ARCHITECHNICS, INC.
510 MAINE STREET
QUINCY, ILLINOIS 62301

PROJECT NO. : 6454

ADDENDUM NO.: 1
ISSUED: 10/27/2023

Project: New Dry Fertilizer Storage Building
Frankford Farm Services
Frankford, MO

1 BUILDING SECTION
 SCALE: 1/4" = 1'-0"

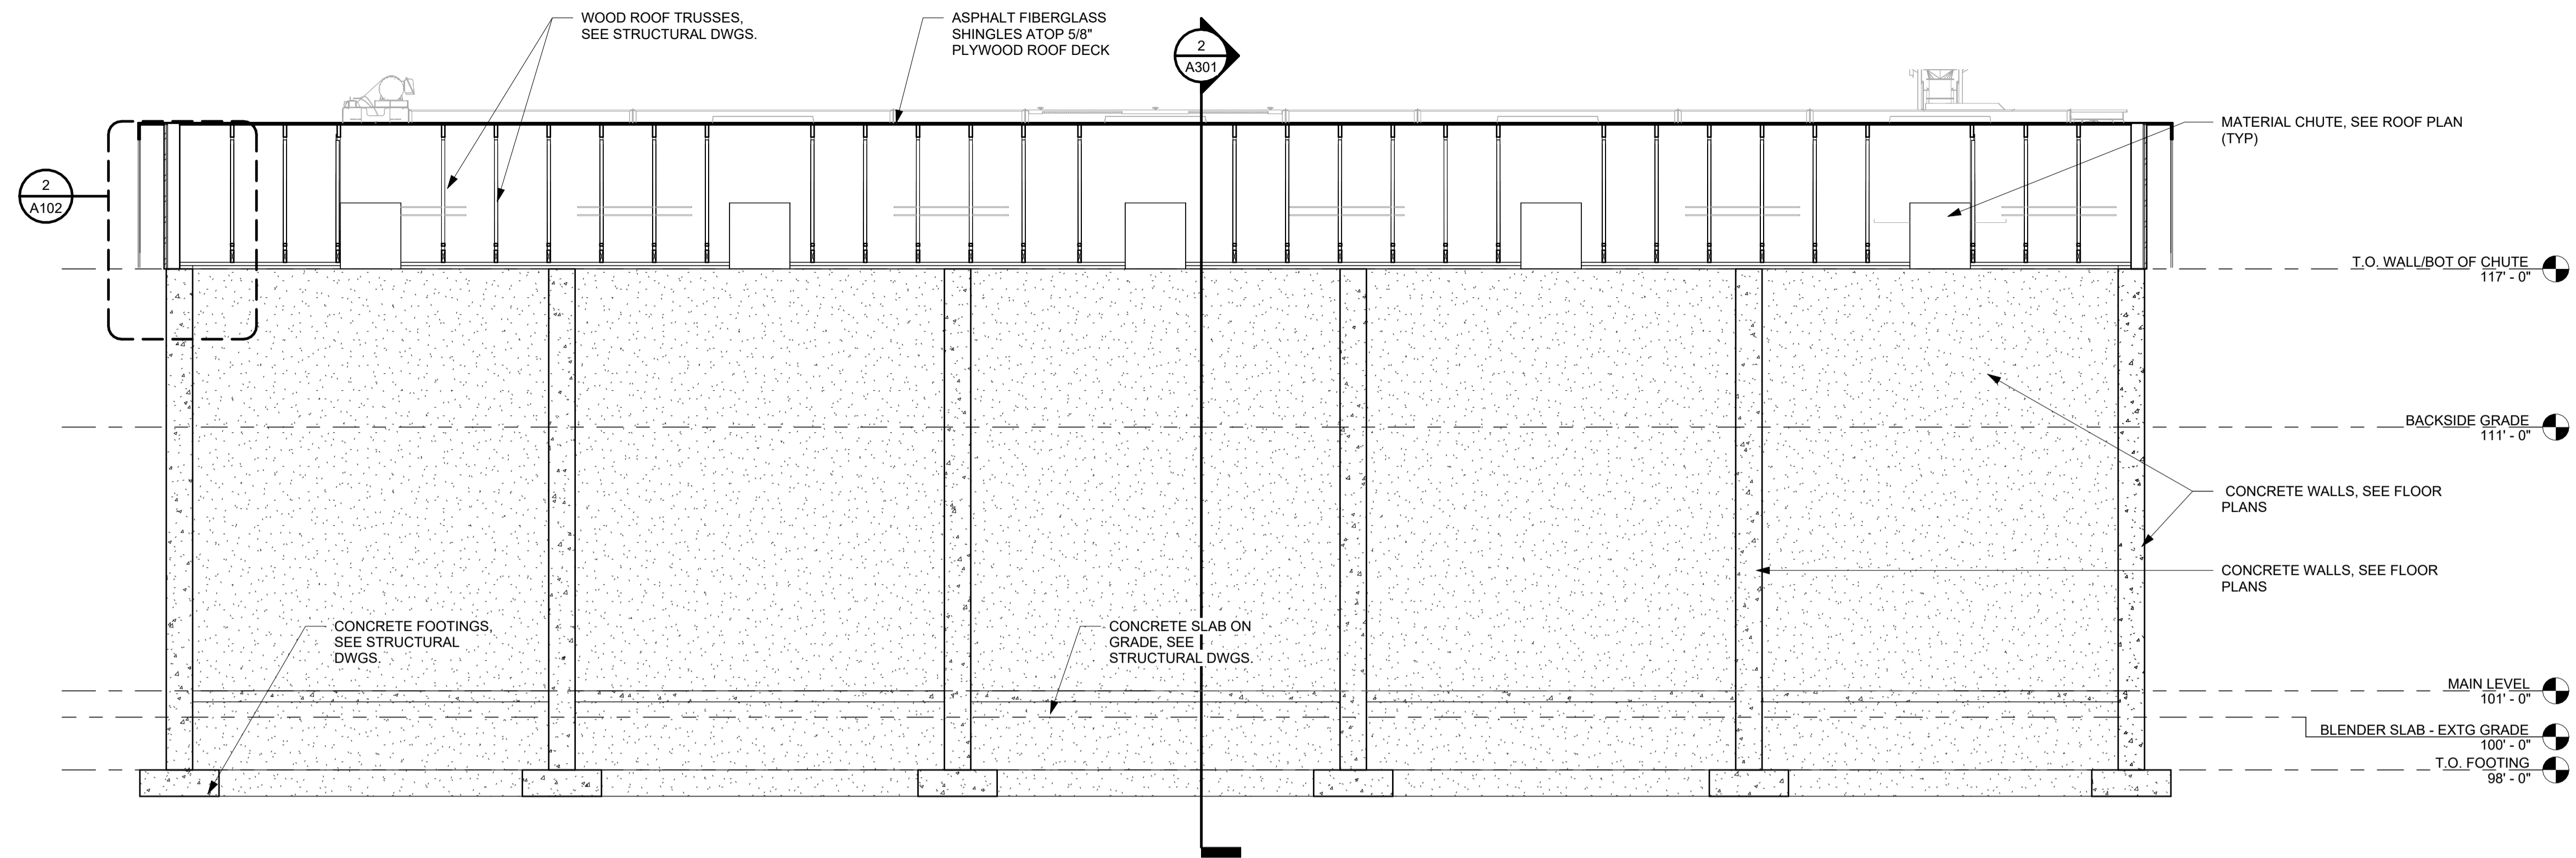
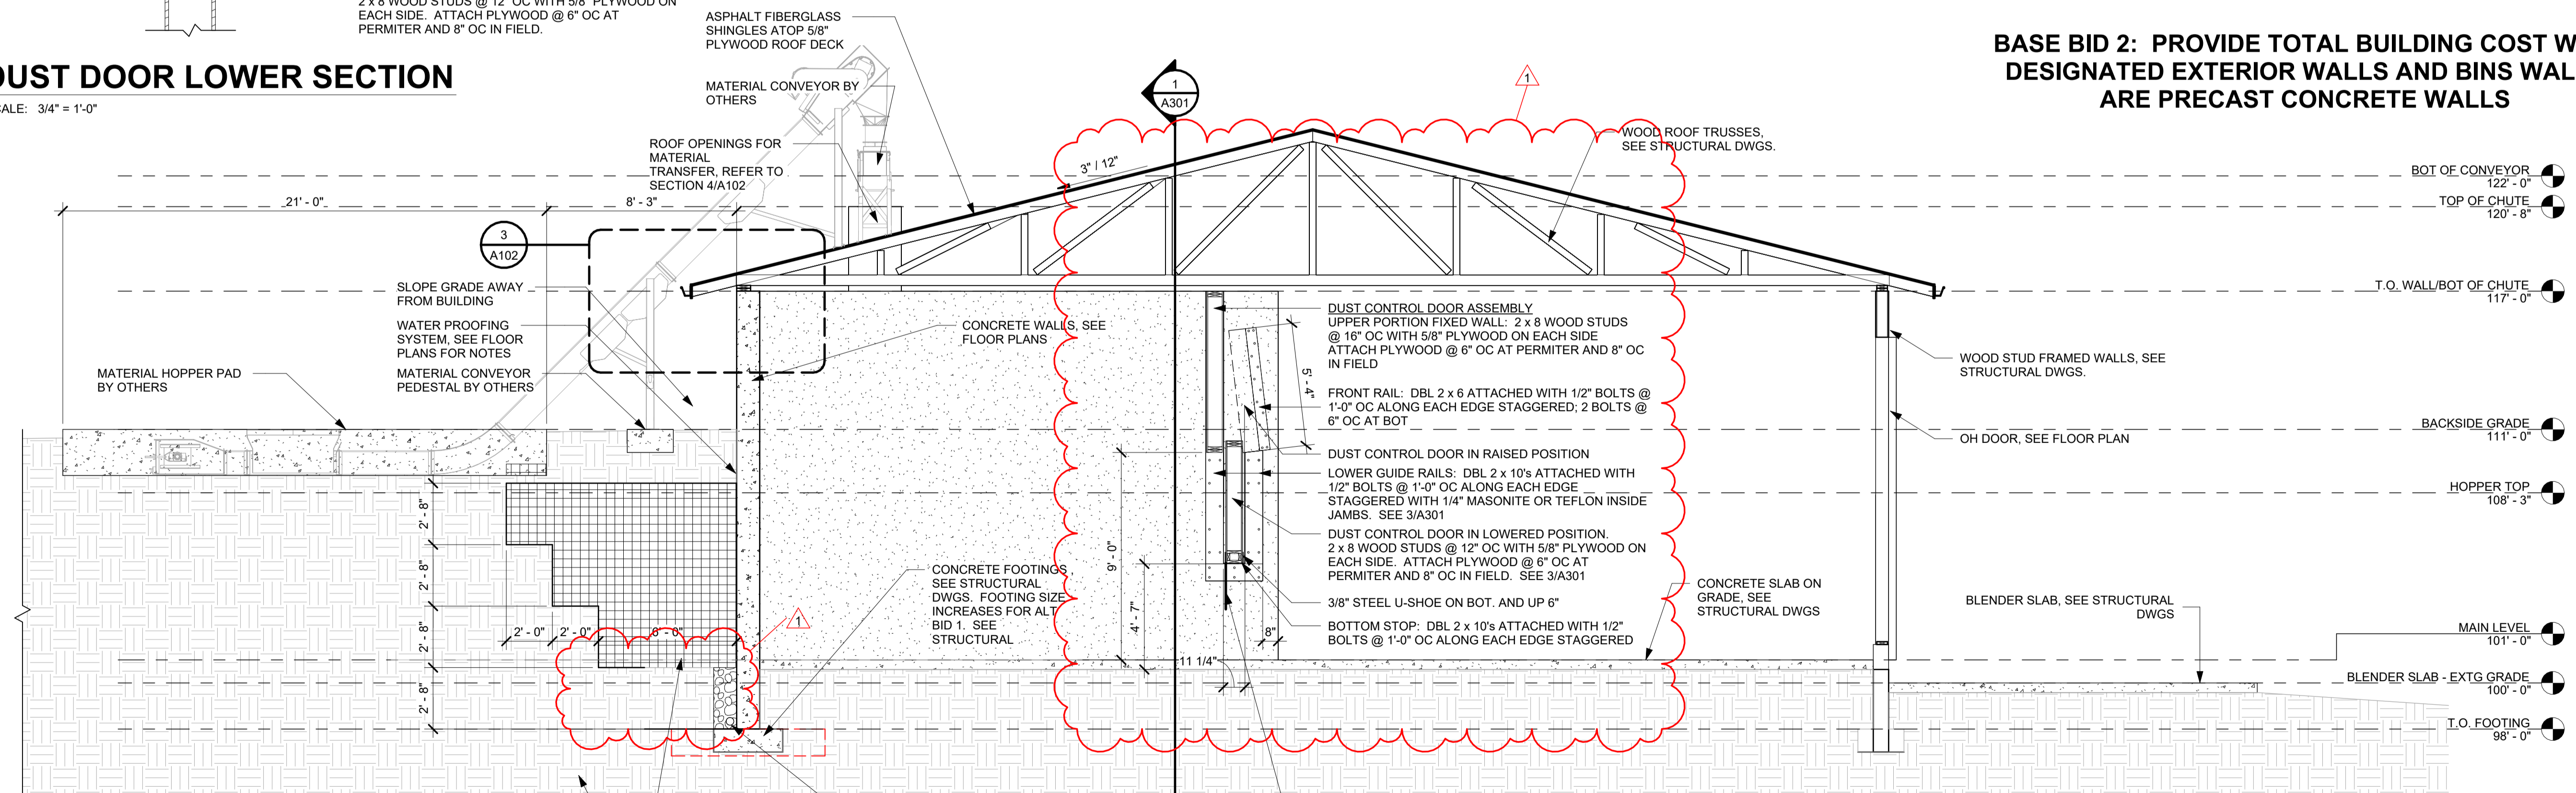
RED DASHED LINE IS REQ'D FOOTING SIZE AND WALL THICKNESS FOR ALT BID 1 WITHOUT GEOFOAM. SEE STRUCTURAL DWGS

32" TALL X 24" OR 48" WIDE X 48" (TYP) LONG EPS 22 GEOFOAM BLOCKS. SEE 2/A301. CONTACT RYAN KING WITH ATLAS ROOFING CORPORATION (314-886-1045 / rking@atlasroofing.com) QMIT GEOFOAM FOR ALT BID 1
